Product Change Notification

Change Notification #: 113269-01
Change Title: Intel® Compute Module HNS2600JFQ and **HNS2600JFF**
PCN113269-01, Product Material
Change the material of tray latch cap from rubber to polycarbonate
Reason for Revision:
Add Additional Product SKU
Date of Publication: October 23, 2014

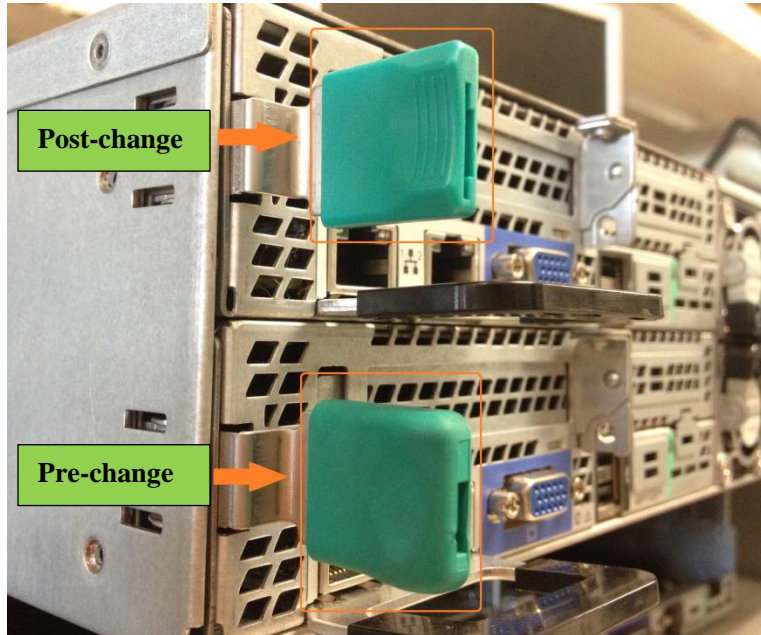
Change the material of tray latch cap from rubber to polycarbonate to avoid pulling the cap out from the tray latch.

See below picture: the lower one is pre-change cap and the upper one is post-change cap.
